Service Bulletin

Bulletin No.: 19-NA-220

Subject: Loss of Propulsion, Malfunction Indicator Lamp (MIL) Illuminated - DTC P0A3F and/or P1B03 Set

5409321

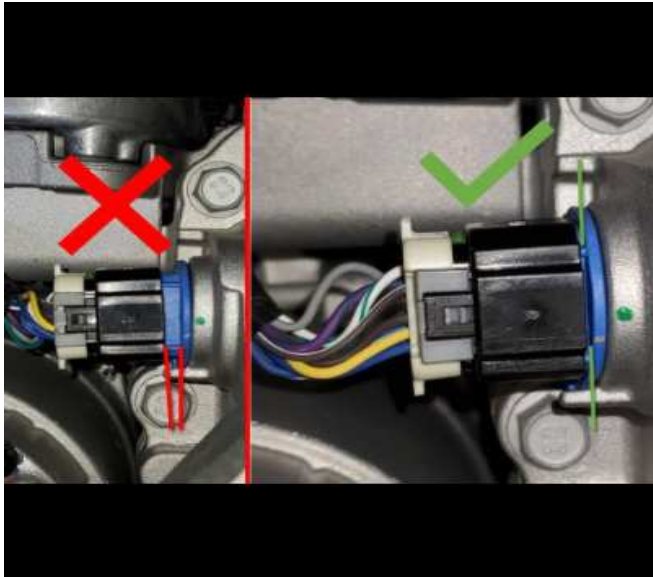
Example case of damaged terminals. Terminals do not need to have visible damage to set DTCs P0A3F and P1B03.

Ensure that the connector is fully seated.

5409322

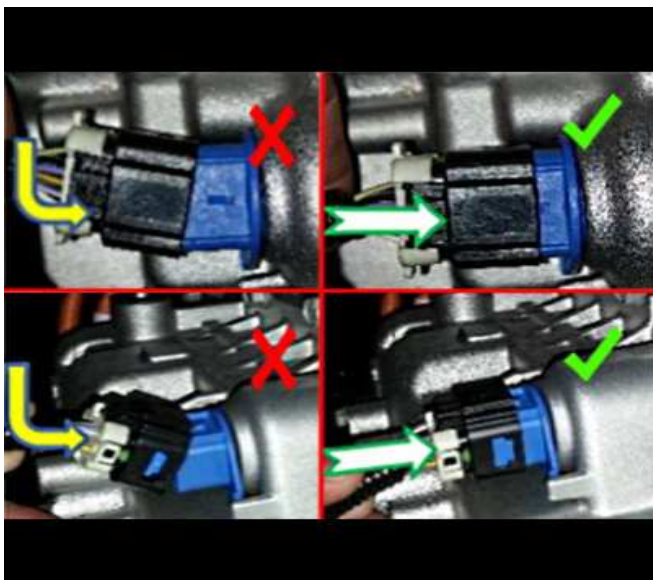
Showing both proper and improper alignment of the X2 connector.
